NOTICE OF VIOLATION

Project Name: On-going construction of housing units for Core Tech International

Water Pollution Control Program  
Water Division  
Guam Environmental Protection Agency  
Inspection Report

On-Going Core Tech International (Former LADA) Housing Project, Dededo, Guam

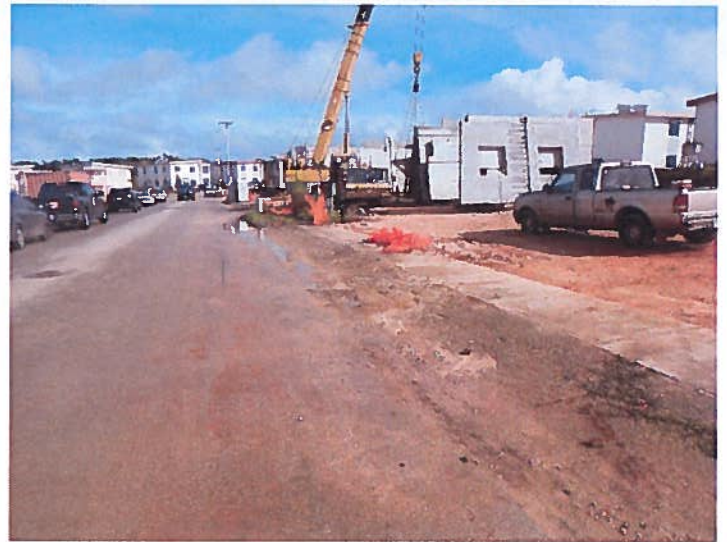
**Finding:**  
 No Sediment Protection and Stormwater Inlet Protection at the on-going construction site.  
*Pls. see picture above*

1. Instruct Mr. Noel Quogna Core Tech Site Project Engineer to install BMP's, sedimentation control and stormwater inlet protection ASAP.
2. Issue NOV to Core Tech International to correct all deficiencies noted during the site inspection no later than Feb. 6, 2019.
3. A follow-up inspection will be conducted by Guam EPA on Feb. 7, 2019 @ 9:00 AM to verify if all deficiencies noted on the NOV/site inspection report have been corrected.

**Photo No. 1**

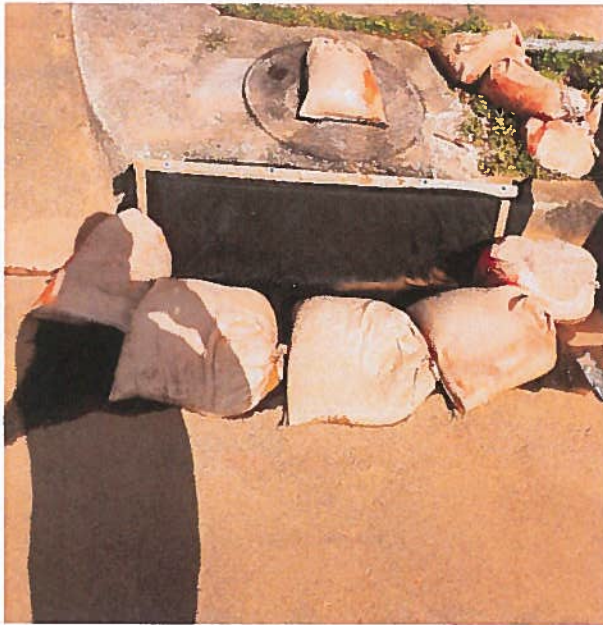
On February 6, 2019, 10:05 AM, GEPA Staff: Helen Gumataotao and Maricar Quezon conducted an inspection of the Core Tech Housing project to see if they corrected their erosion sediment control (BMP's). As per Mr. Noel they redid their BMP's and added fabric along with sand bags over storm drains and inlets. (See photo No. 1) During our walk through with Mr. Noel, they had their water truck wetting down the road way to help control the dust around the site. (See photo No. 2)

Erosion Sediment control: Above photo shows Core Tech has redone their BMP's and added fabric for more protection. As per Mr. Noel they will maintain their BMP's on a daily basis.

**Photo No. 4**

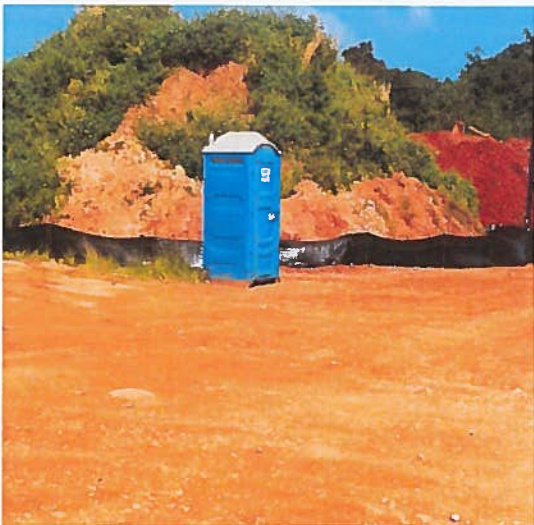
site they now have erosion sediment control barriers in place around their stockpiles. (See photo No. 4) They also added a swale at the entrance of the stockpile lot to help prevent runoff, as per Mr. Noel they will continue to work on their entrance exceedance to further protect the area. Further erosion sediment control barriers are being place along the unstable area and will also be maintained until the area has stabilized. (See photo No. 5)

Erosion sediment control barriers can be seen around their stockpiles.
